SAN ANTONIO WATER SYSTEM
48-INCH WATER MAIN – MICRON TO ANDERSON TANK PHASE II PROJECT

SAWS JOB NUMBER 10-7002

ADDENDUM NO. 1
September 9th, 2011

PLANS FOR WATER WORKS CONSTRUCTION

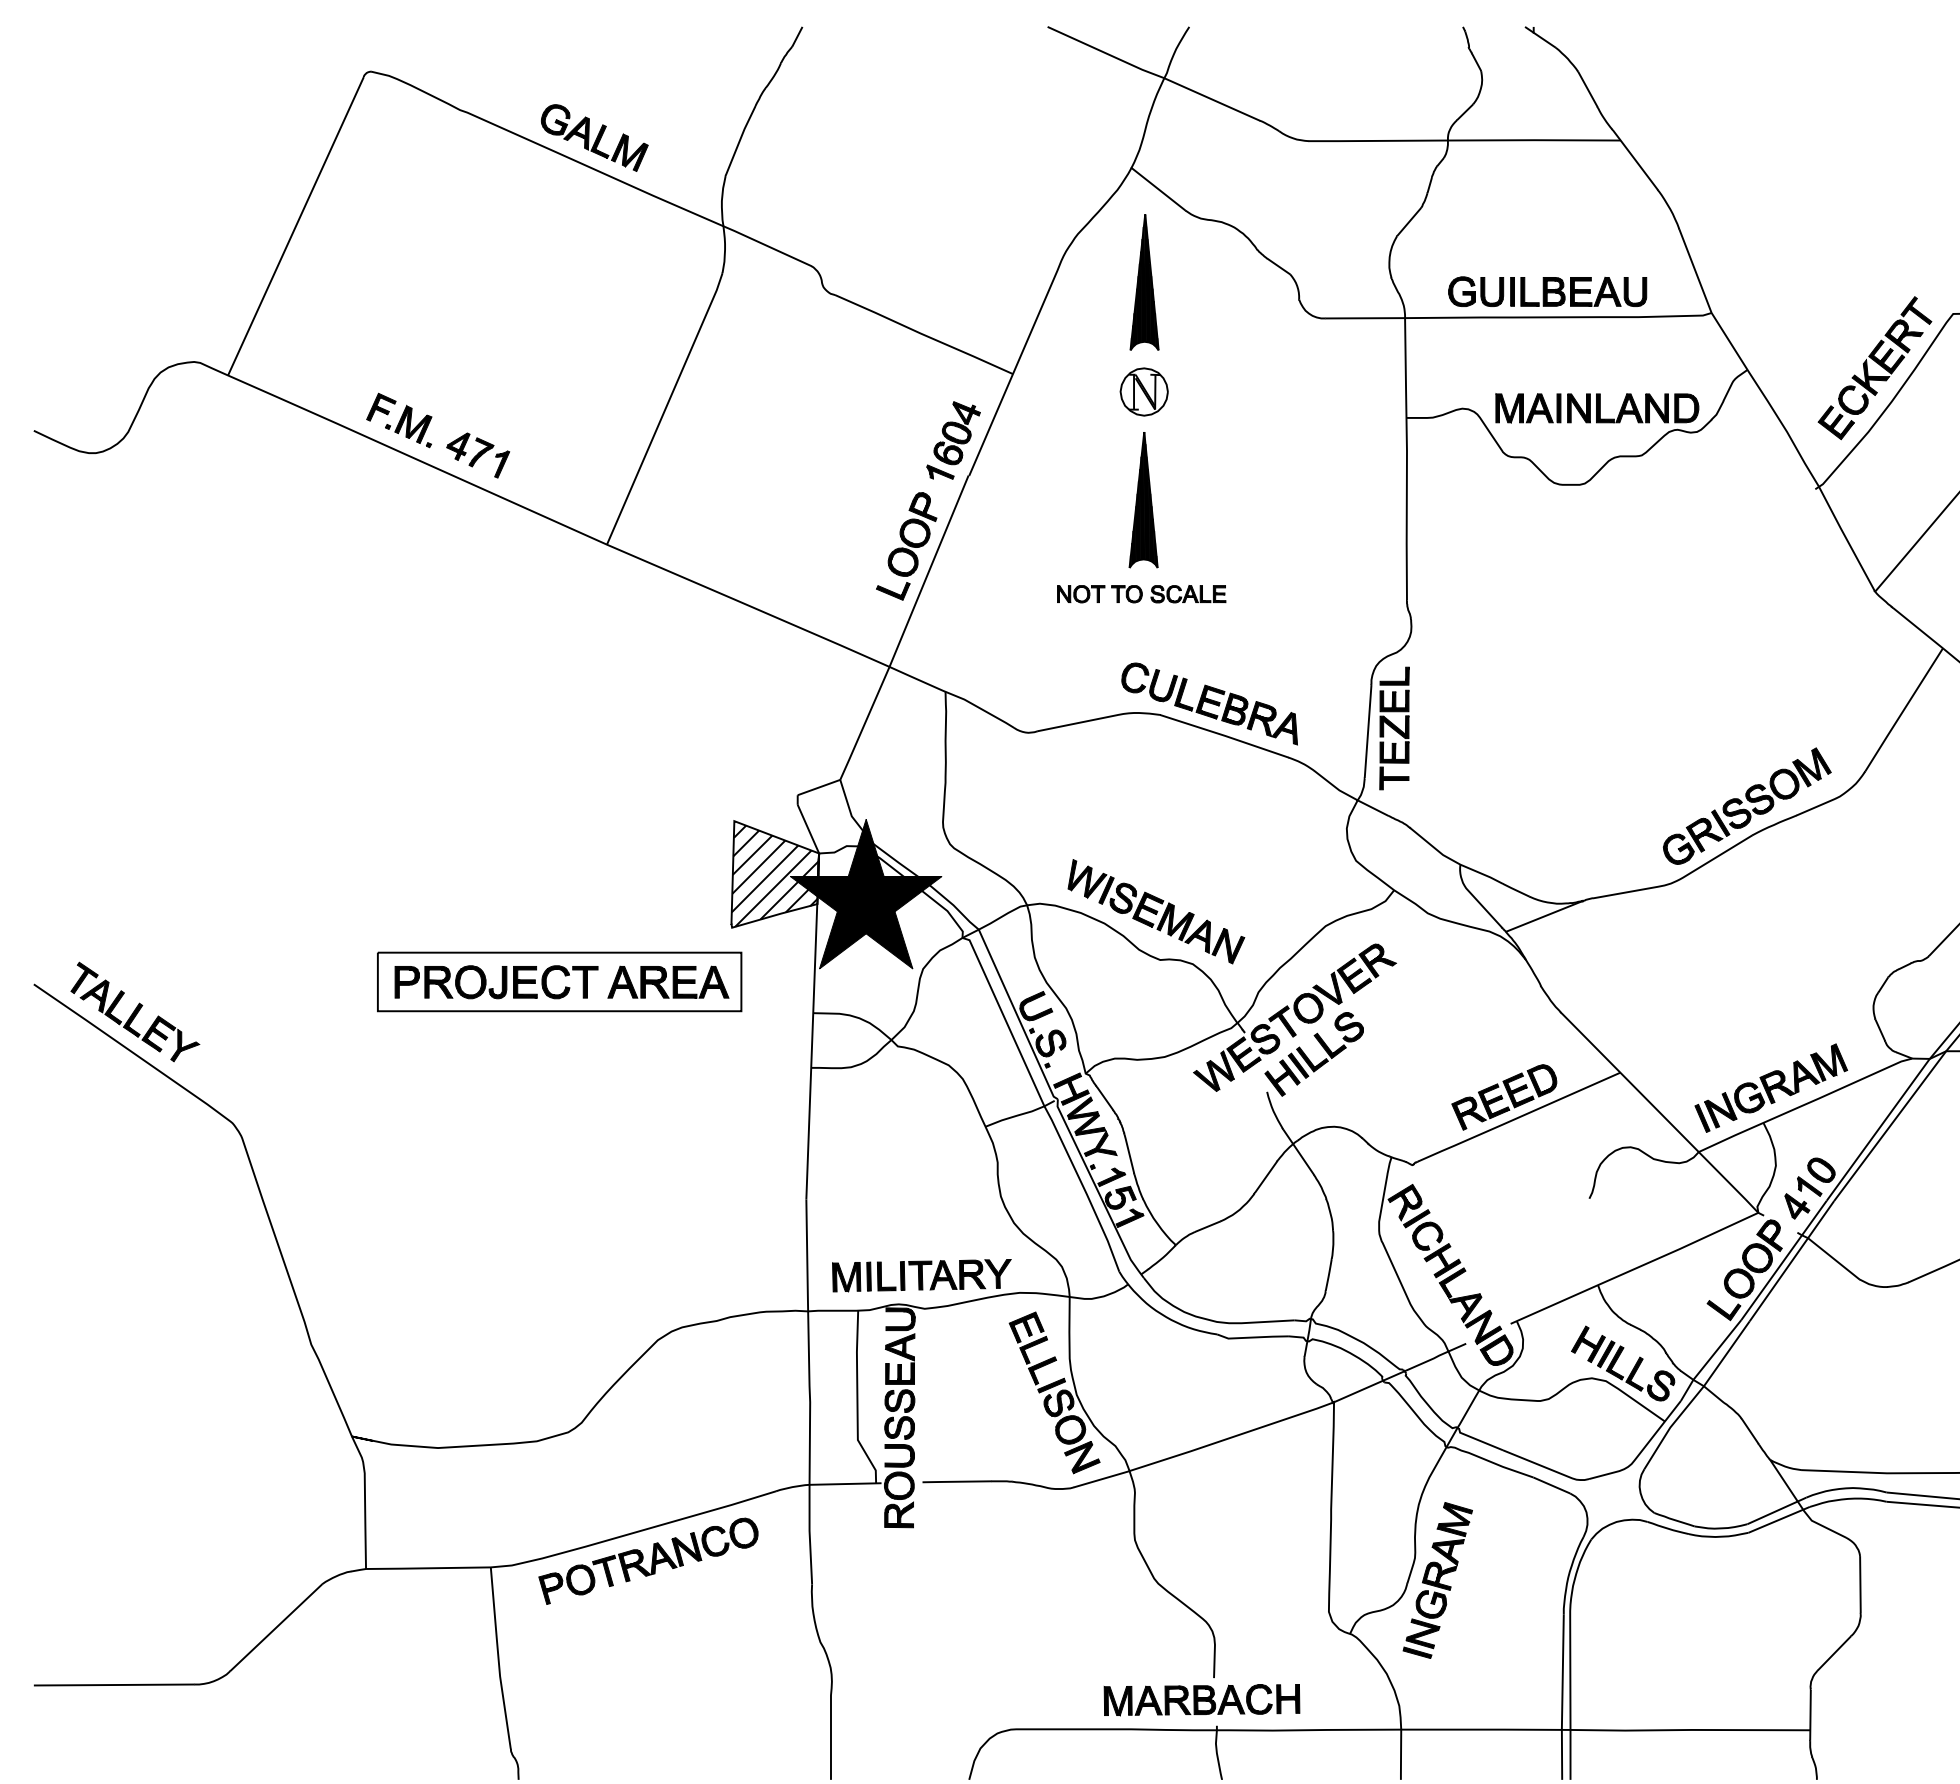
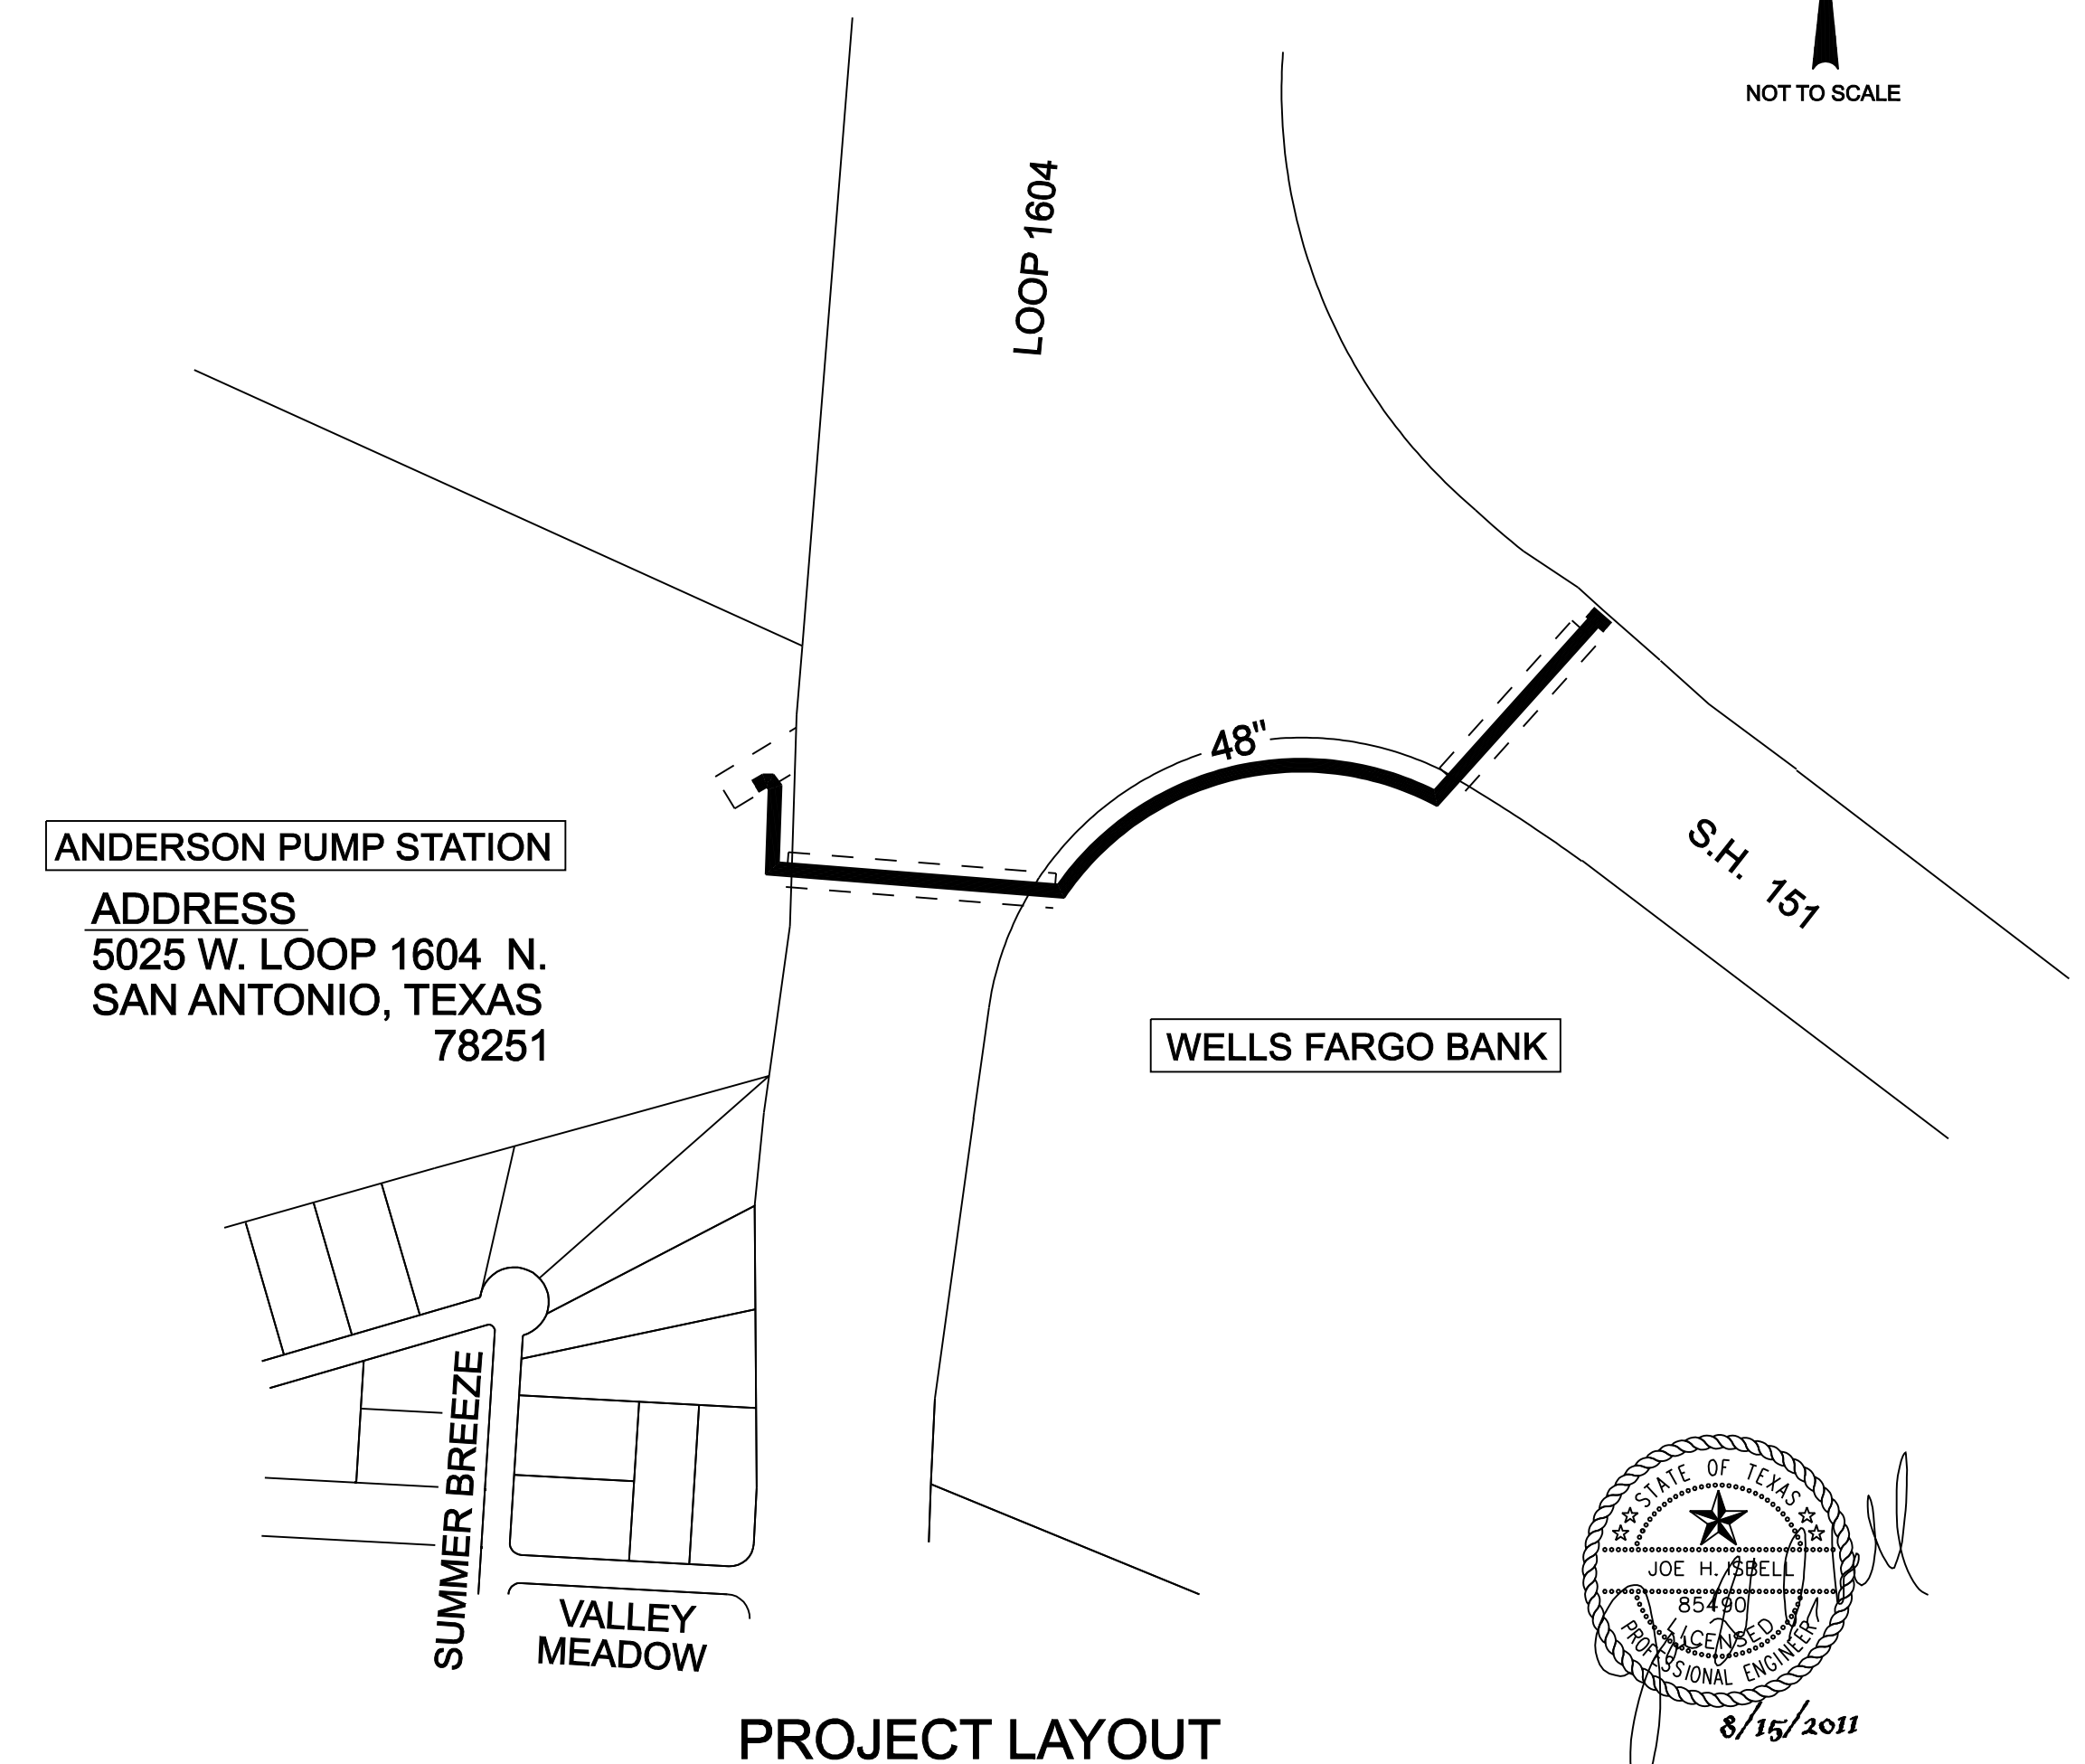
Sheet 1 – Cover Sheet

Delete the following item(s) from the plan and profile portion for this sheet:

Sheet Index on Cover Sheet for Tree Plans and Details, TP1 – TP8;

Add the following item(s) to the plan profile portion for this sheet:

Tree Plans and Details, TP1 – TP5

See attached revised Cover Sheet enclosed herein.
